Product Change Notice (PCN)

Subject: RZ/G3E Product Mask Version Change

Publication Date: 9/12/2025

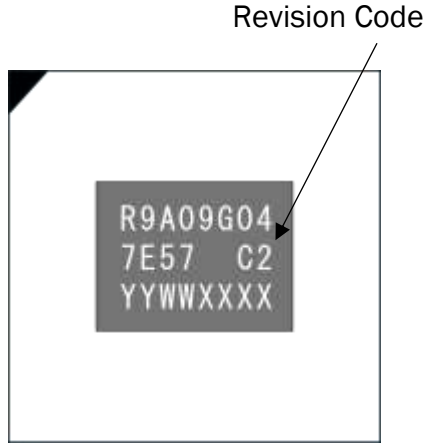
Revised products can be identified by the revision code 'C2' marked on the package or by reading the value from the LSI Device ID register. Additionally, for the revised products, the last digit of the booking part number will be changed from 0 to 1.
